Office Action Summary

10/771,550

This is an office action for serial number 10771,550, entitled System and Method of Mounting a display screen via a pendulum type mount.

FIG. 1

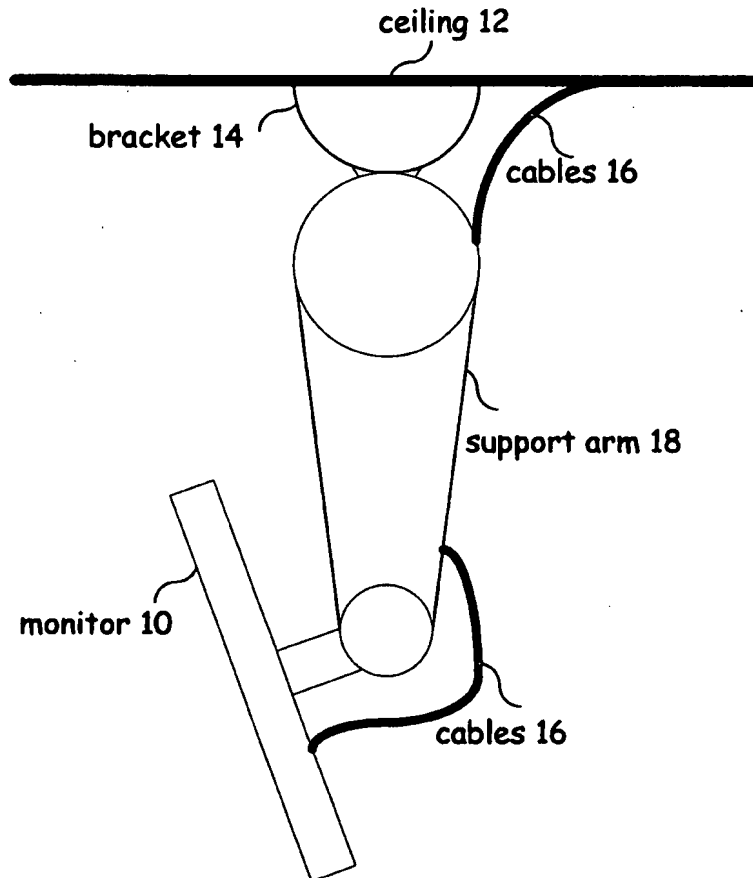
The drawings are objected to because the figures should not include words within the drawings. The figures should only include reference numbers not a name for each part. Corrected drawing sheets in compliance with 37 CFR 1.121(d) are required in reply to the Office action to avoid abandonment of the application. Any amended replacement drawing sheet should include all of the figures appearing on the immediate prior version of the sheet, even if only one figure is being amended. The figure or figure number of an amended drawing should not be labeled as "amended." If a drawing figure is to be canceled, the appropriate figure must be removed from the replacement sheet, and where necessary, the remaining figures must be renumbered and appropriate changes made to the brief description of the several views of the drawings for consistency. Additional replacement sheets may be necessary to show the renumbering of the remaining figures. Each drawing sheet submitted after the filing date of an application must be labeled in the top margin as either "Replacement Sheet" or "New Sheet" pursuant to 37 CFR

The disclosure is objected to because of the following informalities: The figures should not include words within the drawings. The figures should only include reference numbers not a name for each part.

dis approved 6/10/17
